Show profile locations and other site features (dimensions, reference or benchmark, and North).

6/30/10 - SITE VISIT w/ MR. MONTANEZ

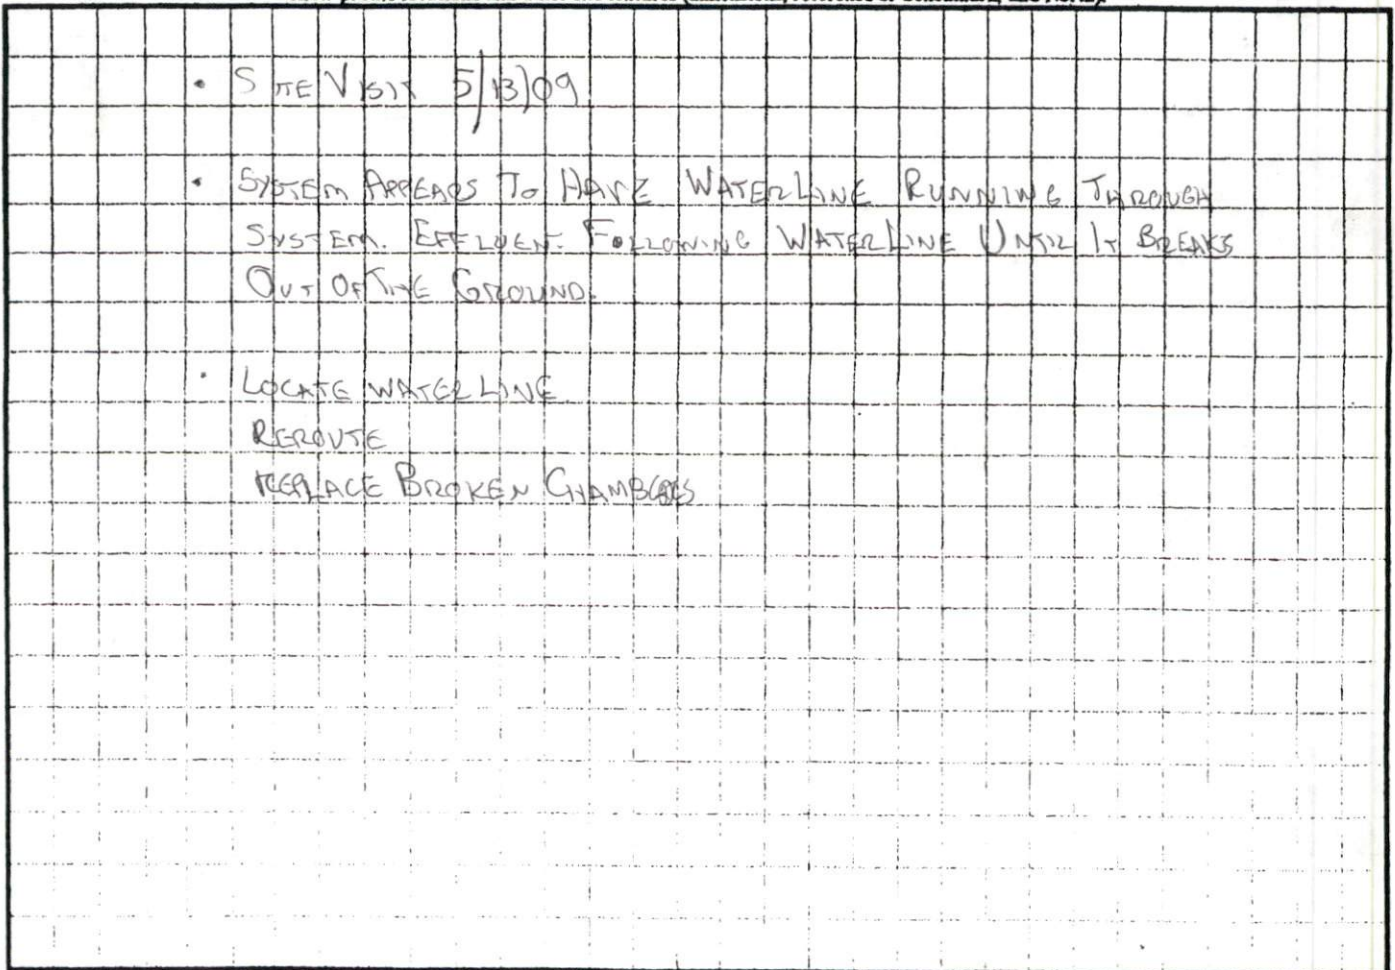
7/20 - Site Visit To Inspect Uncovered Waterline. Water Line Installed Directly On Top Of Chambers, No Visible Damage.

7/22 - Spoke w/ Mr. Jernigan. Told Him To Move Water Line. He Stated That Would Move The Water Line Behind The Bushes On The Side P2 and Circle Around Behind The Tank.

7/27 - Site Visit - No Further Action Taken Yet. Water Line Still Exposed And Not Moved
